HyNet Pipeline and HN1.7 Holywell Rd / Green Lane, Ewloe

Council Position Statement

Planning Act 2008 (as amended) and The Infrastructure Planning (Environmental Impact Assessment) Regulations 2017 – Regulations 10 and 11 Scoping Request made on behalf of Liverpool Bay CSS Limited for an Order granting Development Consent for the HyNet North West Carbon Dioxide Pipeline proposed from Cheshire, England to Flintshire, Wales.

Supplementary Local Authority Response: The Deposit Flintshire LDP

HyNet Pipeline and Housing Allocation Ewloe

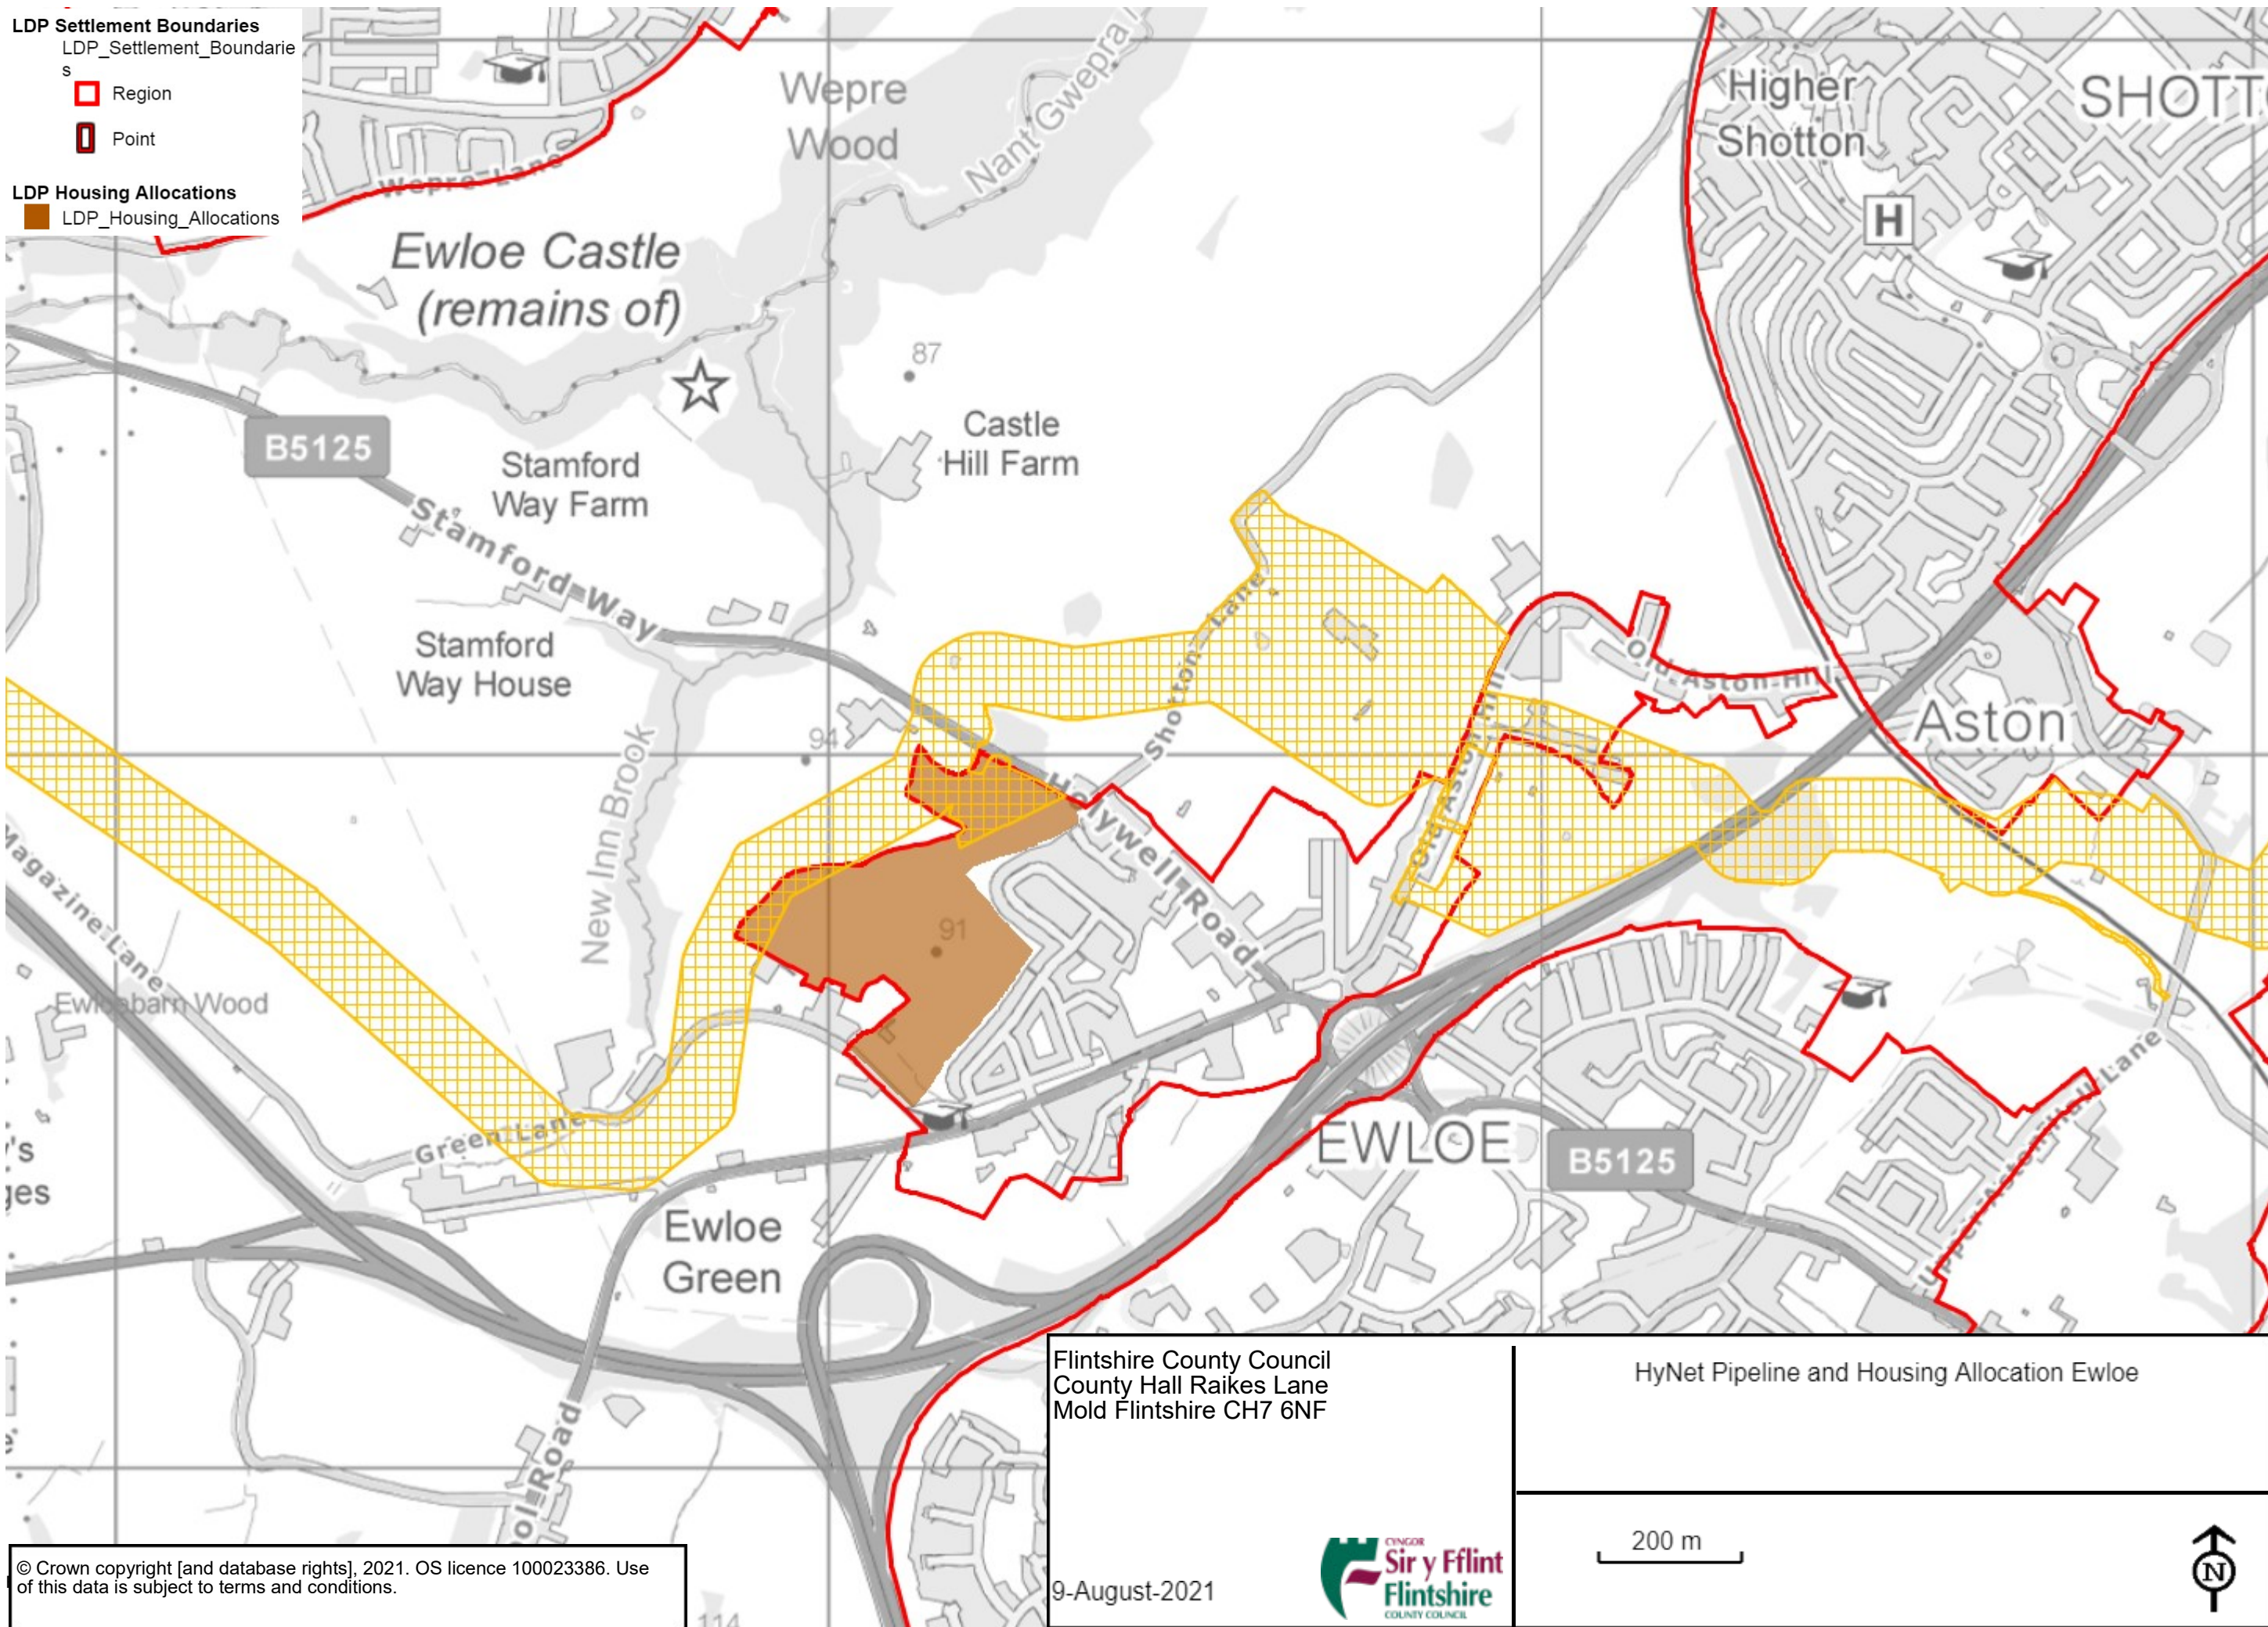
The enclosed pdf shows that the proposed route conflicts with a proportion of the housing allocation 'HN1.7 Holywell Rd / Green Lane, Ewloe' proposed to the north west of Ewloe. This would therefore have an impact on the proposed housing numbers that the allocation could provide, which is fundamental to the housing provision of the Flintshire LDP. The Examination Inspector has been presented evidence in relation to this housing allocation, and has already examined this allocation as part of the Housing hearing session. There is no reason before us why the Flintshire LDP should not include this housing allocation as proposed.
